Hamid Tex Fashion Ltd.

203, Habirbari, Seed Store Bazar, Bhaluka, Mymensingh-2240, Bangladesh
(24.339661, 90.375837)

17th June 2021

Observations

Heavy loading on 1st floor

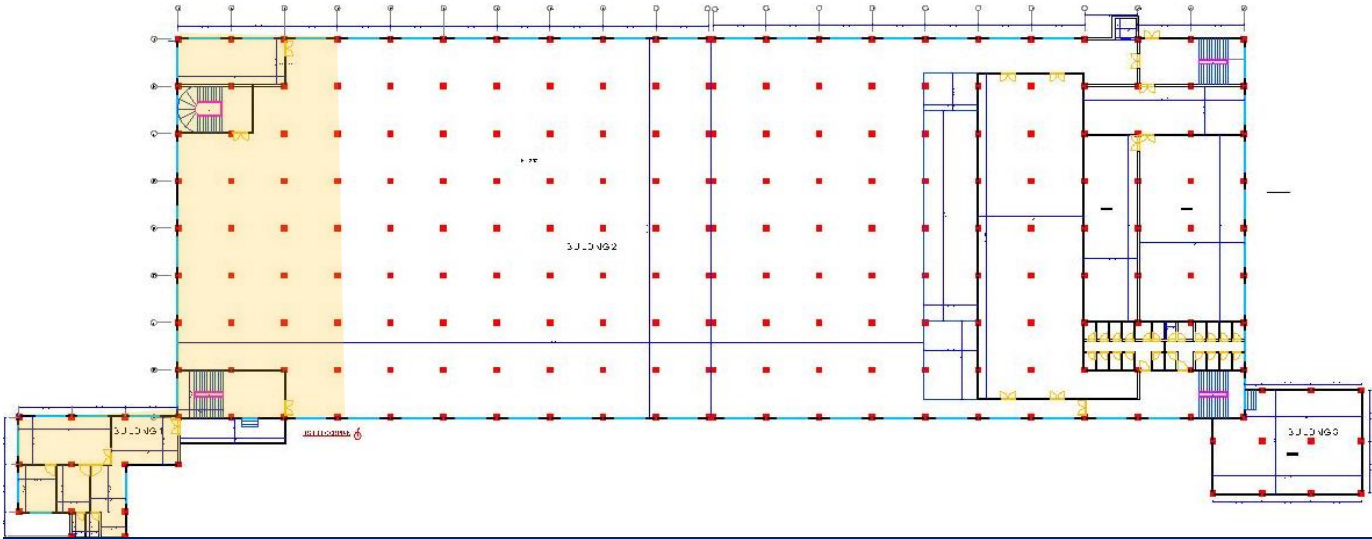
5 to 6 kPa loading was found in storage area(1st floor). Load plan of the building was not produced. Also, load management program was not implemented. Reduce the load to 2kpa immediately. Produce and actively manage a loading plan for all floor plates within the factory considering the floor capacity and column capacity.

1st Floor Roof Slab Layout Plan

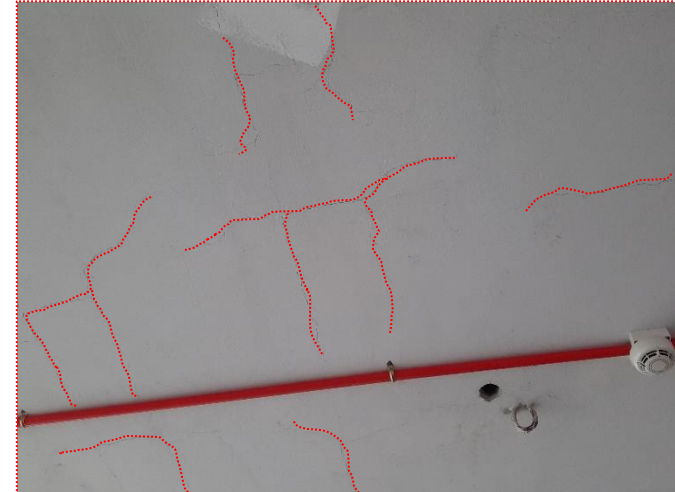
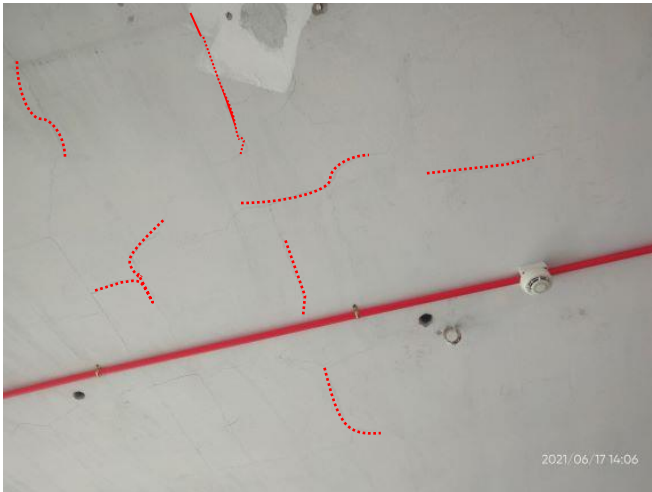
Hairline cracks observed in 1st floor roof flat plate slab soffit. Building engineer is required to check the extent of crack and suggest remedial action.

TYPICAL FLOOR BEAM LAYOUT PLAN

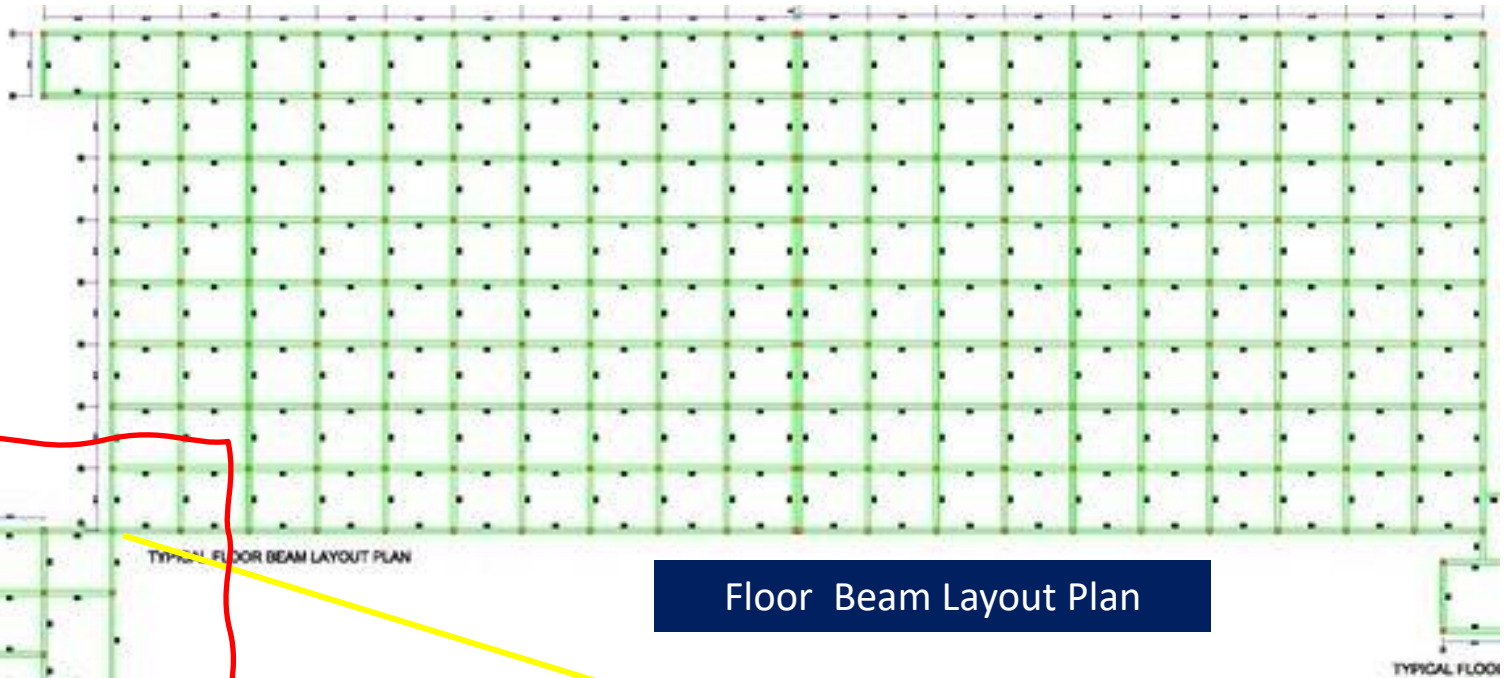
The building is geometrically irregular shaped. Due to lateral forces the building might be affected for torsional irregularity. Building engineer is required to check the torsional effect of the building due to lateral forces.

Floor Layout plan

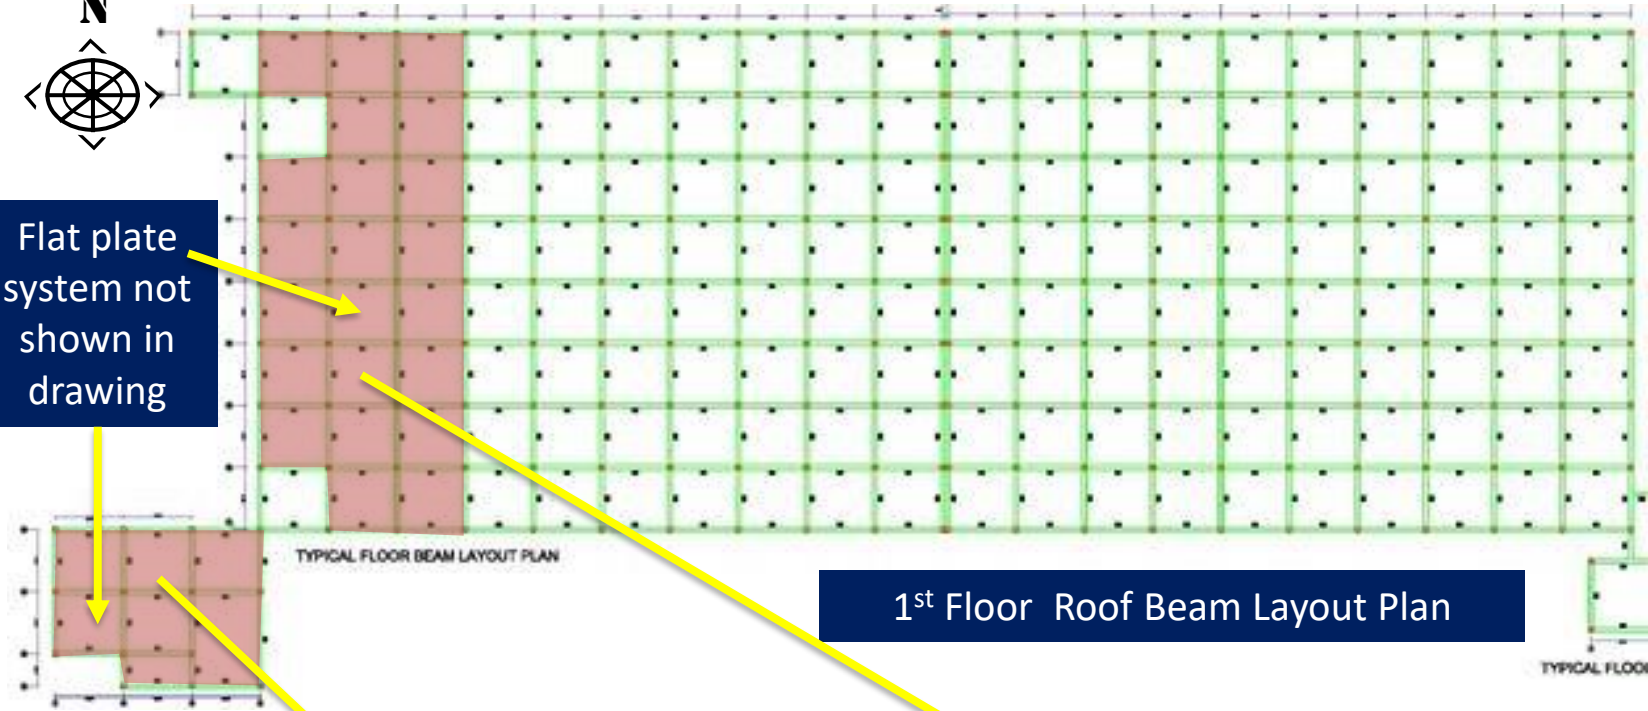
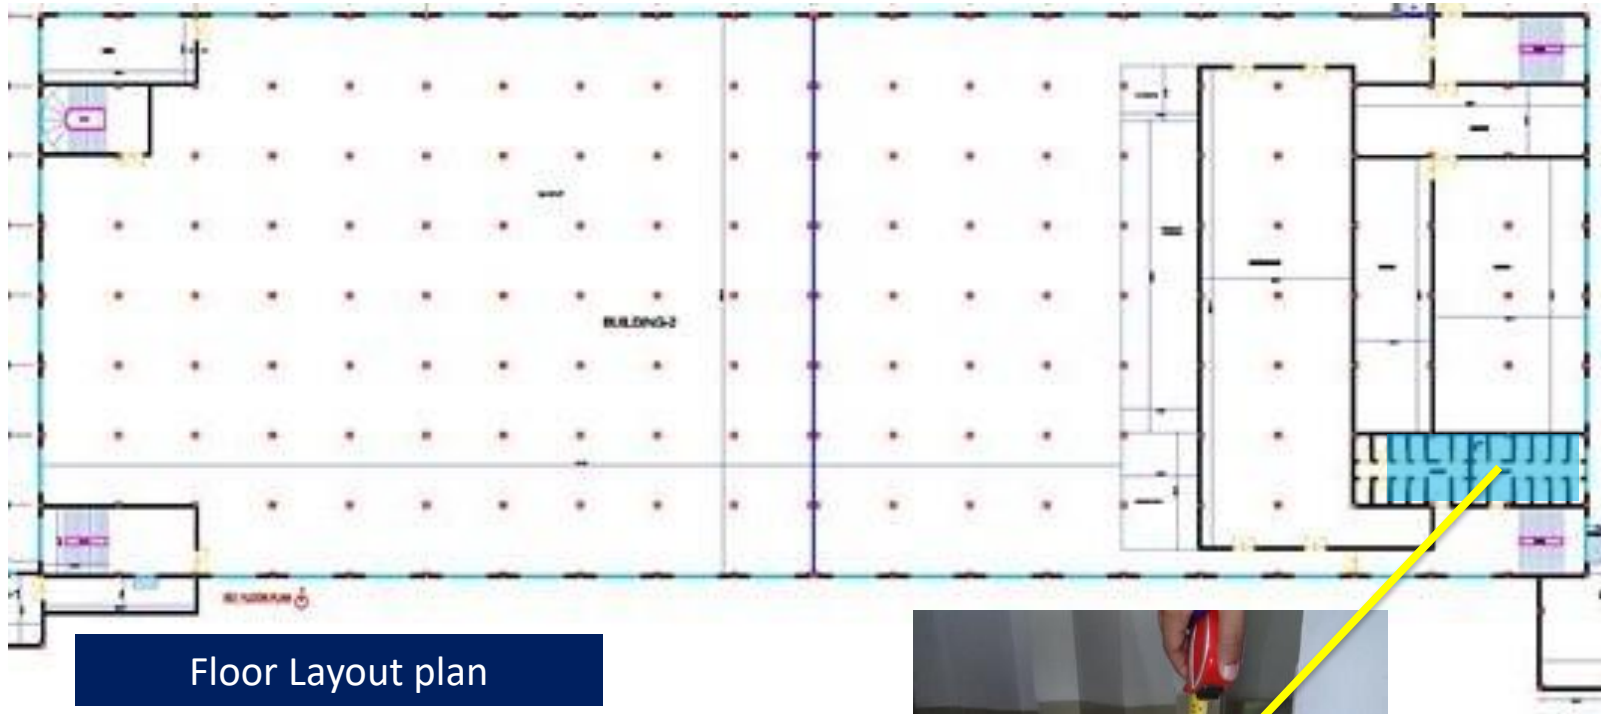
Flat plate system not shown in drawing

500 mm Buildup at 1st Floor Toilet Block.

Water Ponding on Roof

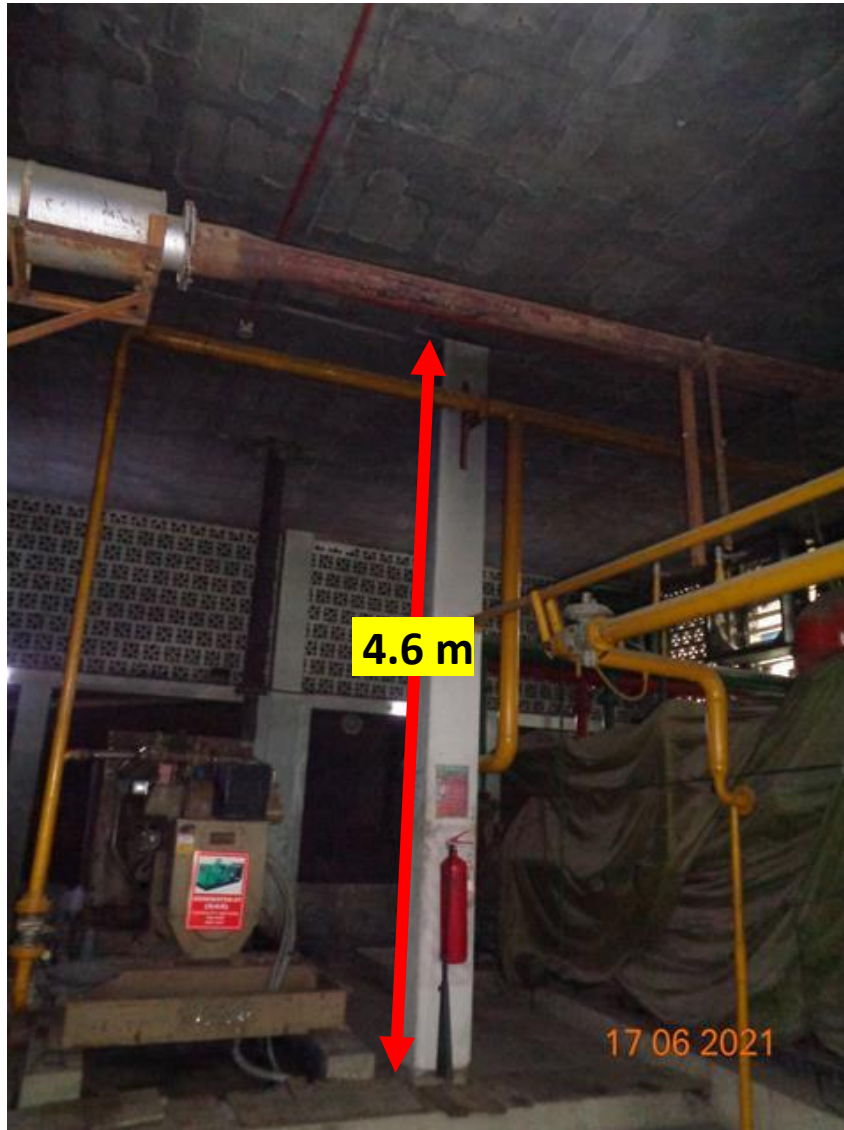
Water ponding observed on the roof. Building engineer is required to develop proper drainage system on roof with adequate slope and apply water proofing compound on roof slab to resist water ingress.

1st Floor Roof Beam Layout Plan

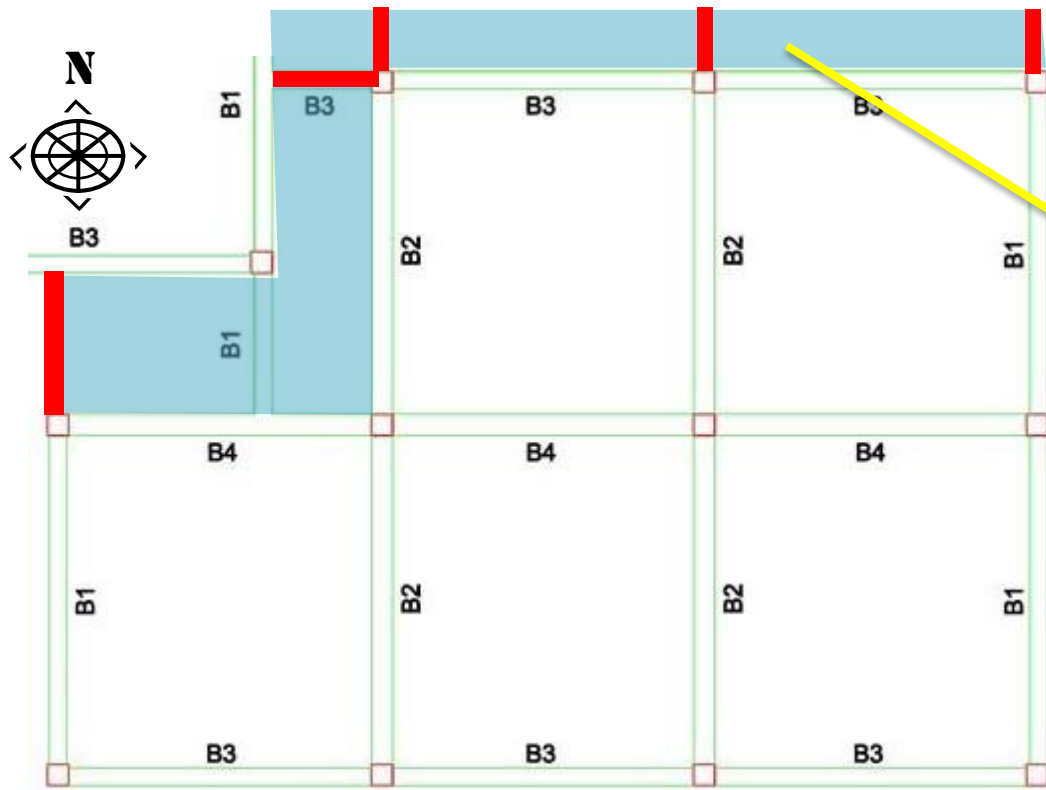
Cantilever Portion-Not Shown in Drawing

Water Ponding on Roof

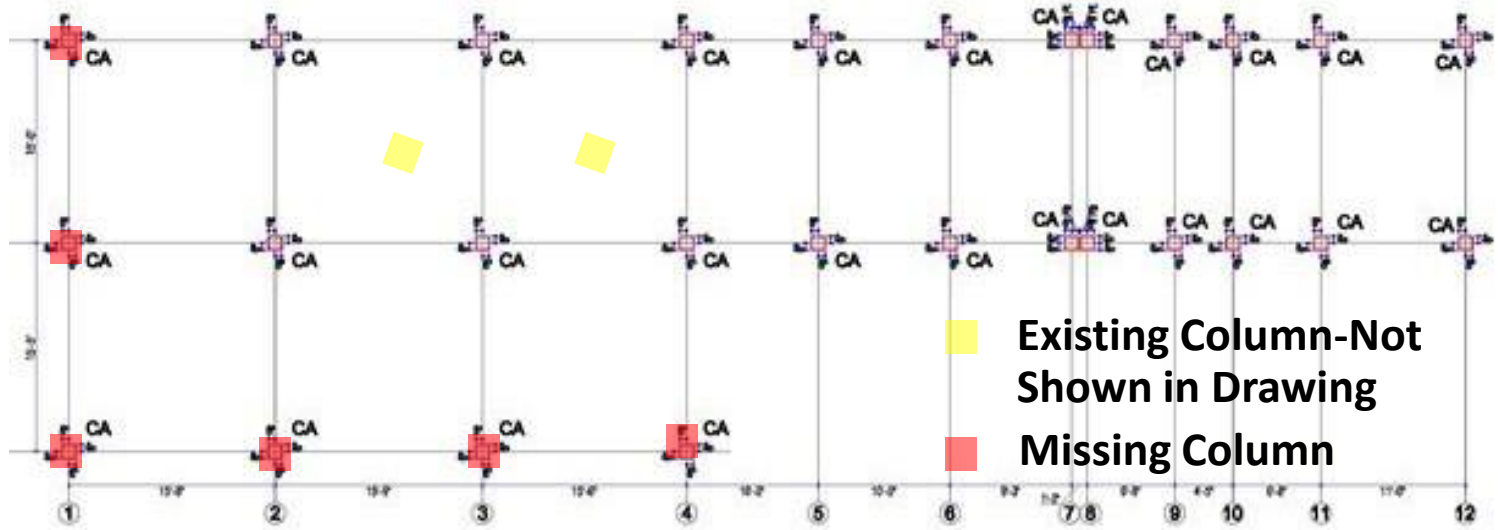
Water ponding observed on the roof. Building engineer is required to develop proper drainage system on roof with adequate slope and apply water proofing compound on roof slab to resist water ingress.

Column Layout Plan

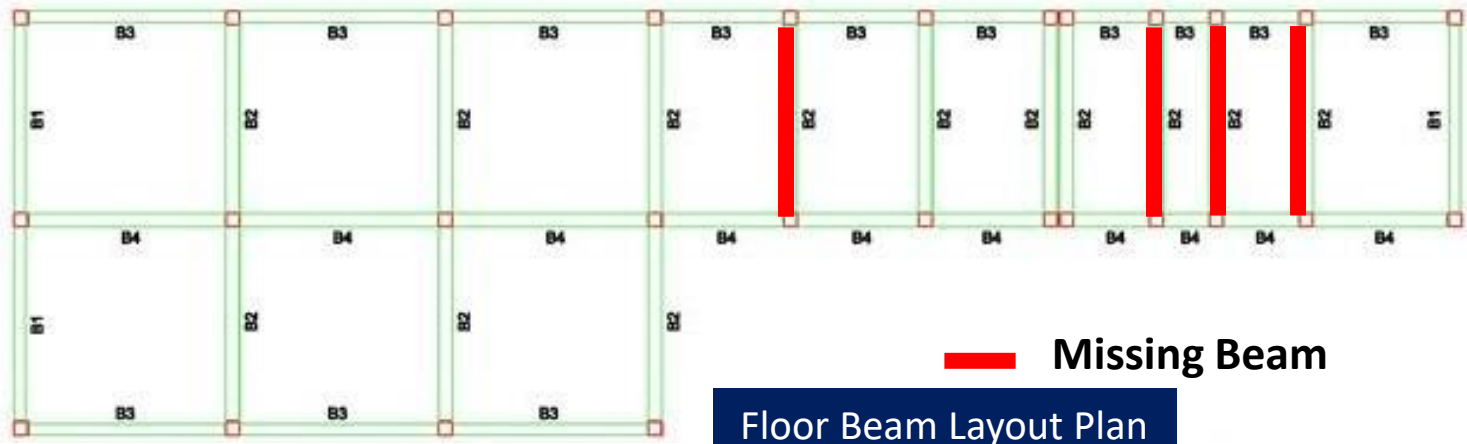
As-built drawings not matched with the site condition. Building engineer is required to survey the structure and prepare accurate as-built drawing.

Non-Engineered Shed

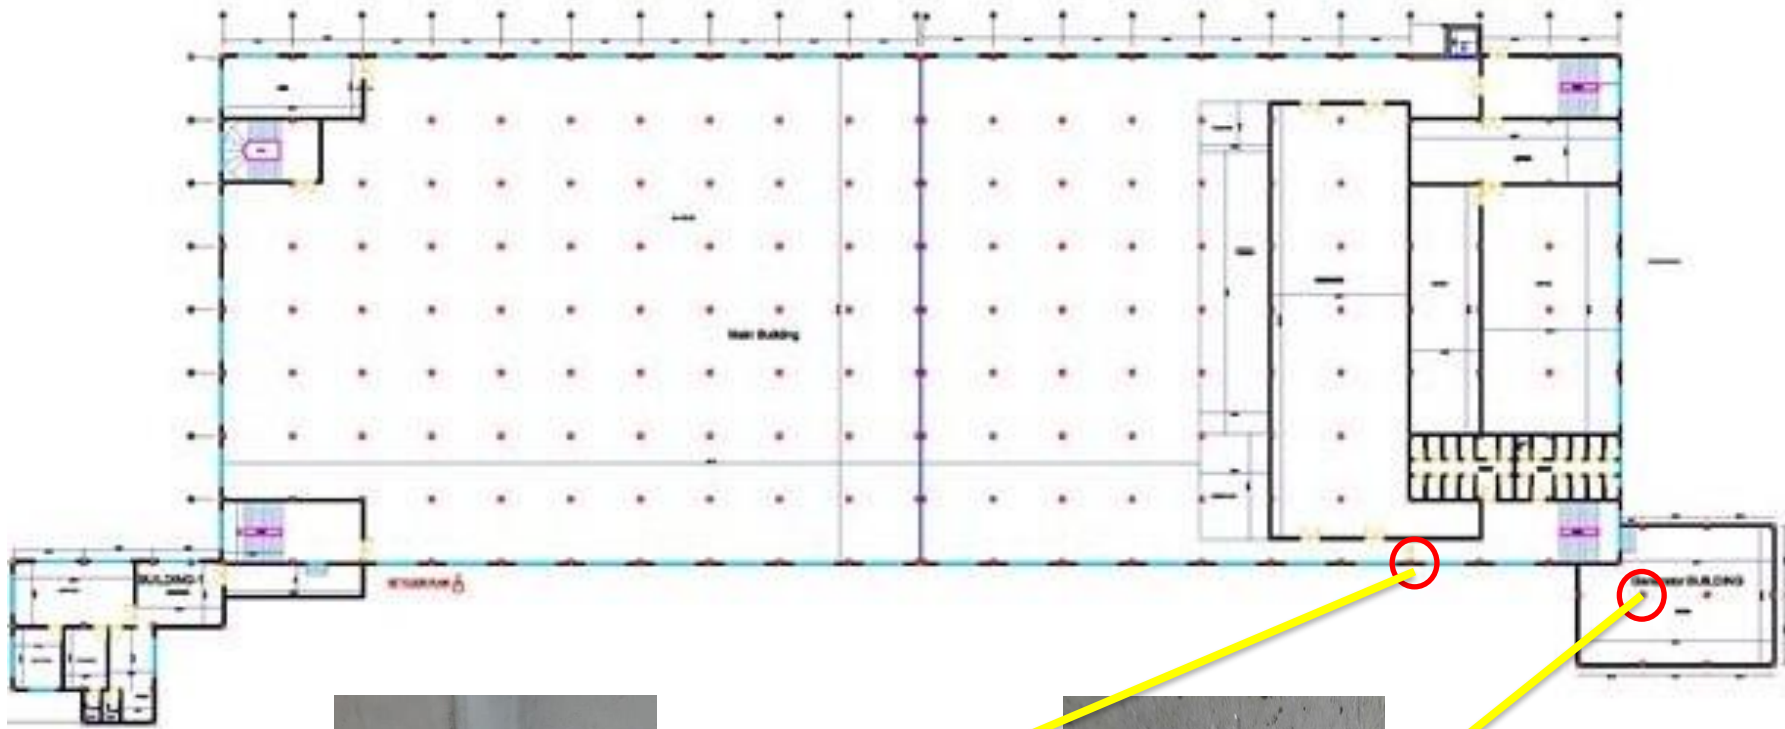
Apparently inadequate steel member, No clear/defined load path, Poor connection details observed. Apparently non-engineered shed. Building engineer is required to check the stability of the shed or replace by an engineered structure.
